## HIT vs TRT Explanation

Thoughts on how to solve the issue of testing the „magenta part“ of the time history „Deployment height vs. Time“:

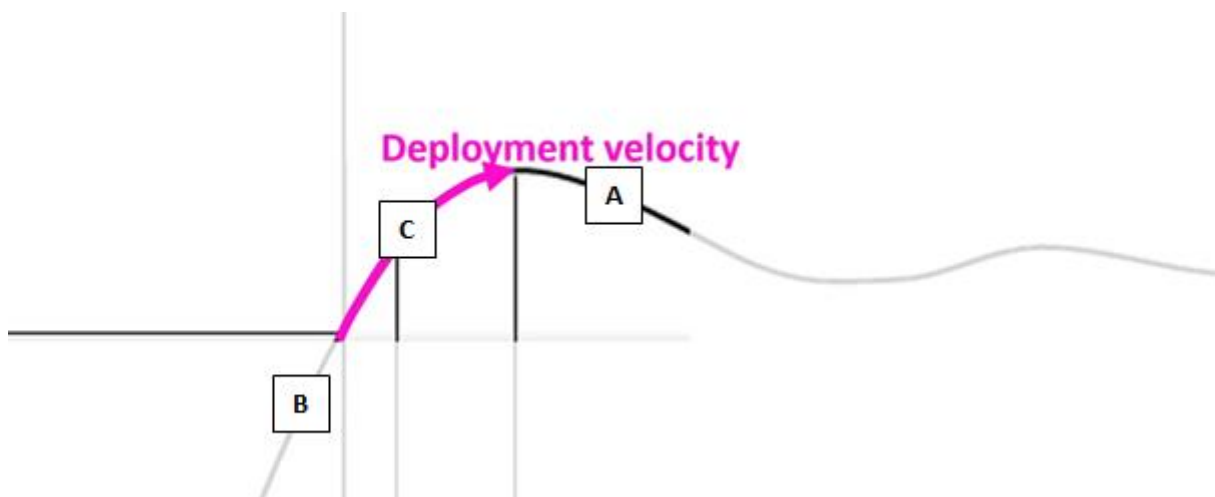
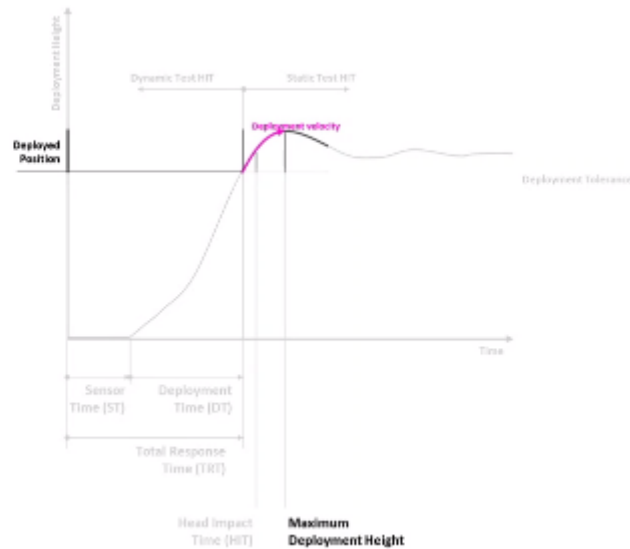
Would a certain oncoming velocity of the DPPS increase HIC values significantly?

In case the HIT is on the right side of the magenta part of the curve (A), the test may be performed statically.

In case the HIT is on the left side of the magenta part of the curve (B), the test is to be performed dynamically.

In case the HIT is on the magenta part of the curve (C), we give two options in square brackets which are:

[(C-1): The test is to be performed dynamically]

[(C-2): The test may be performed either dynamically or statically.]

The square brackets in the proposal may be removed if we are able to conclude whether the oncoming velocity of the bonnet can have a significant negative effect on the HIC result (then C-1 is valid) or not (then C-2 is valid). If we cannot conclude in the IWG, then the two options are handed over to GRSP to decide.
